**To:** The Assessment Manager for DA/42/2023

**Subject:** Proposed material change of use of premises for a bulk landscape supplies  
2654 Round Hill Road, Agnes Water Q 4677 (Lot 5 RP612151)

## **Assessment Report Refuting Material change of Use DA/42/2023**

Property Location 2654 Round Hill Road, Lot 5 RP 612151

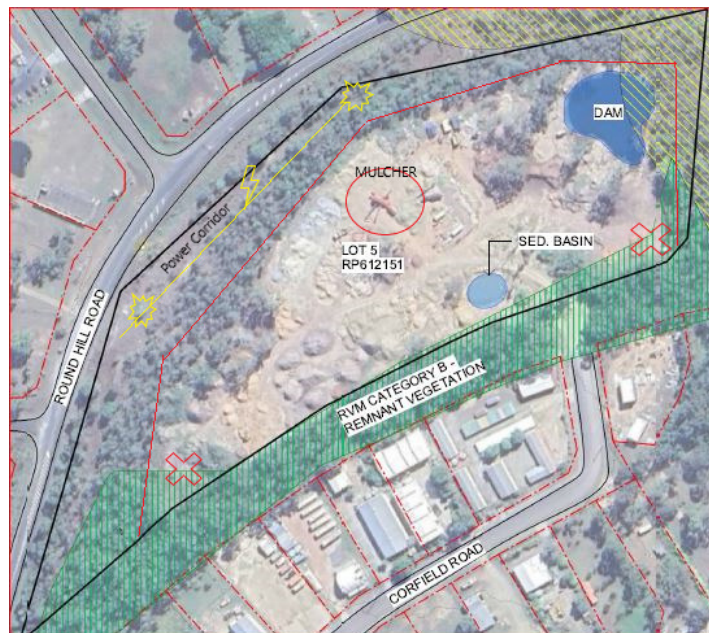
The site is virtually fully cleared, (Planners google image has incorrectly shaded areas, the green hatching is deceptive). Clearing has continued throughout the period of this investigation. Dam and Basin are Brown not blue. I've added some corrections in the bottom image.

It has no sealed roadways or drives, and no proper drains. Nothing has been done to suppress dust aside from waiting for the rain. When it's dry it's a dust pit, the trucks leaving and entering, drag rooster tails of dust with them, as well as dropping rocks and branches from uncovered loads. The onsite operations generate extreme dust and a light wind creates constant dust storms.

When it's wet, the runoff carries fine particulate matter to the wetlands, onwards via the strings of waterholes to Reedy Creek and thereby eventually to the reef.

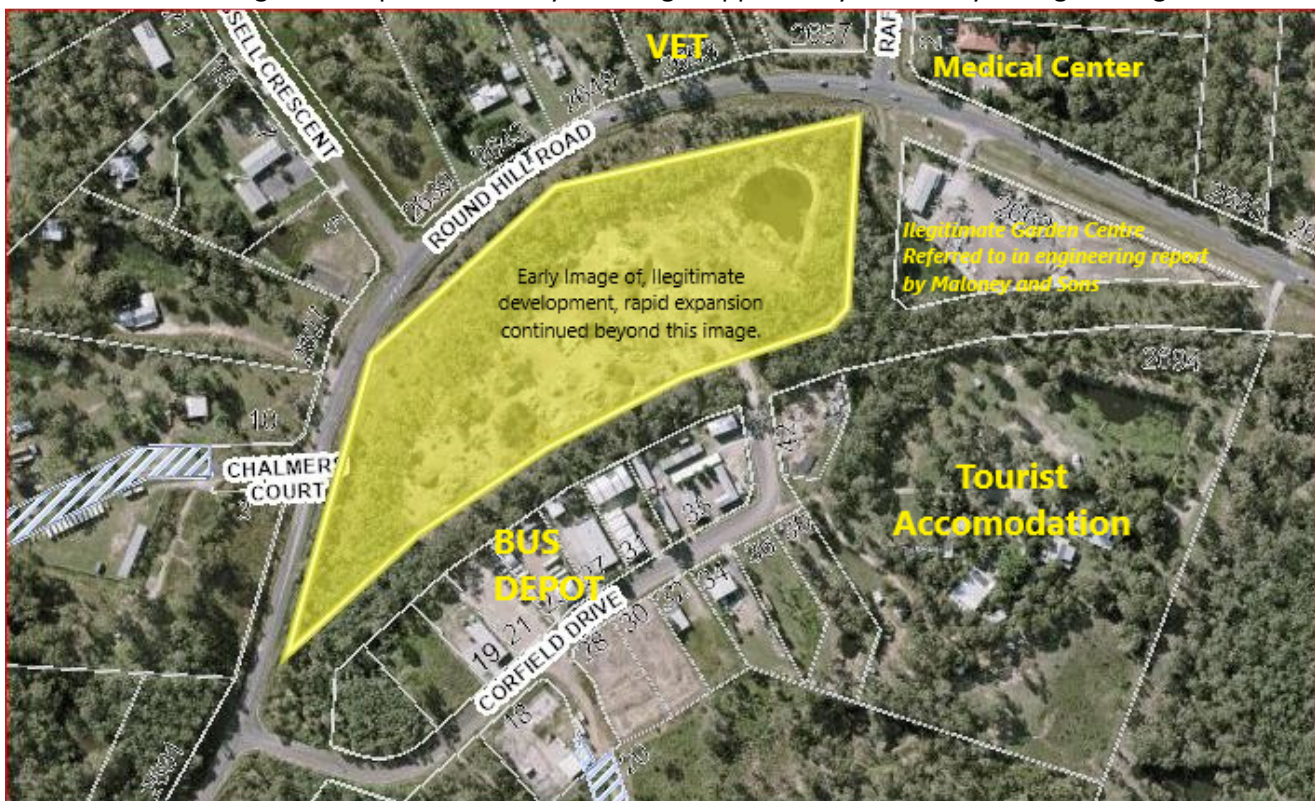
Six proposed parking spaces is a joke, the contractors have more vehicles than that, the few visitor cars that enter are utes, or towing a trailer, and some light trucks that take a few cubic meters, but mostly,

the transport is truck and dog, loaded by excavator, its loud and dusty. And it's not just a one off building site if you let it continue

Image: Google Pro Earth, historical data, May 2021. Site visible lower right hand corner.

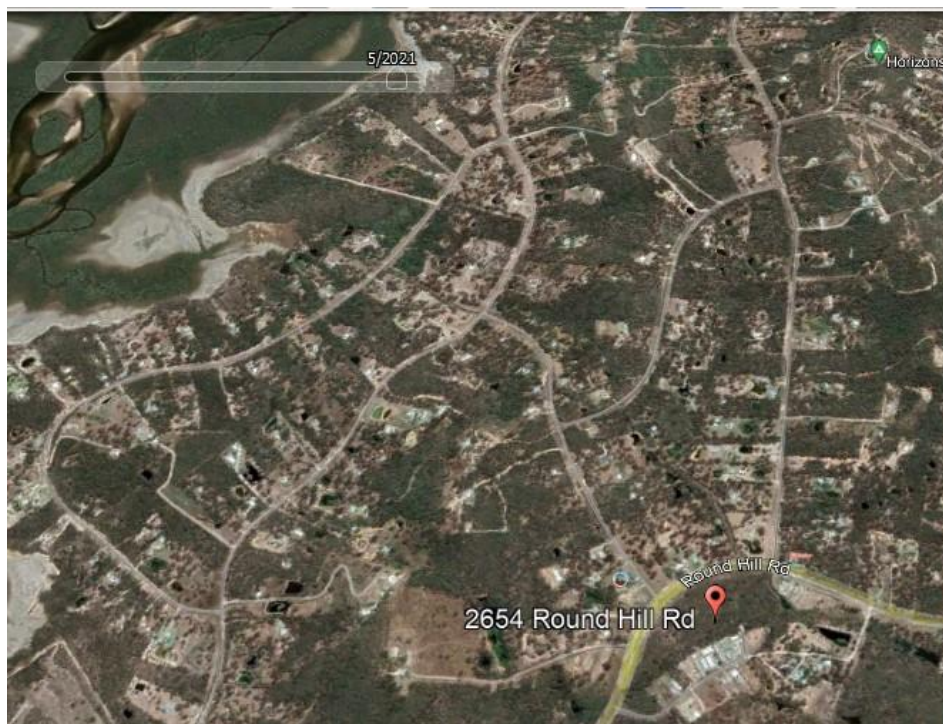
The image above clearly shows the client was not operating prior to this time

Image above from State Planning Policy Interactive Mapping System, Queensland Government

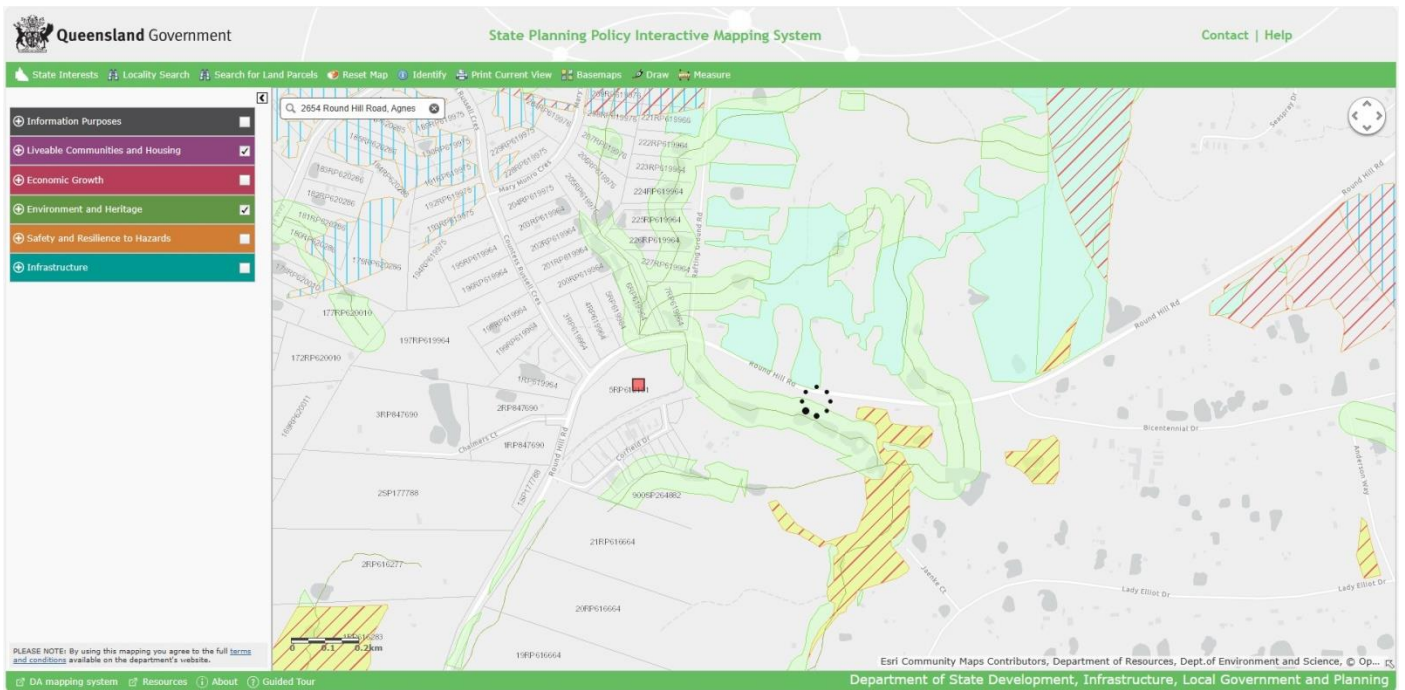
The last image shows the extensive wetland system downstream of the site which would be impacted by the development. That's a lot of properties downstream likely to get sediment and weed seed. Environmental factors have not been taken into consideration.

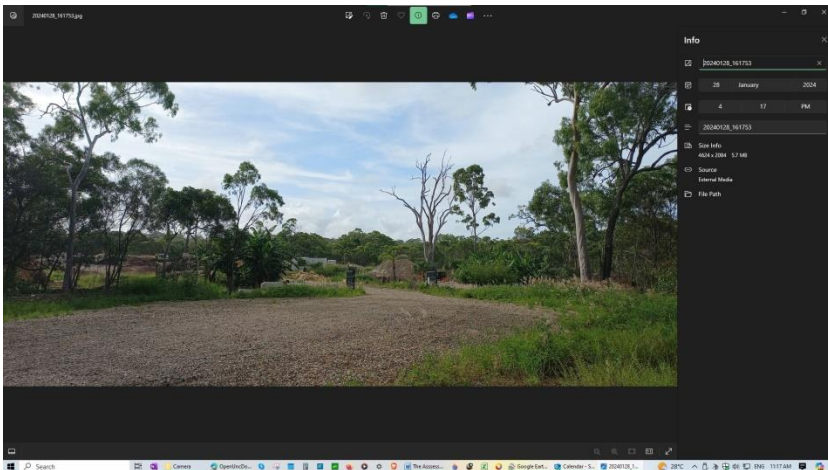
Extrapolating from this snapshot, there would be somewhere around 92 movements per day on week days. **I must emphasise that it was a quiet day with reduced truck activity** when videos were taken.

Additionally – the gates to ACE are often open when I visit Corfield Drive on a Sunday.

Zoom in and you will see this is Sunday 28<sup>th</sup> January after 4pm.
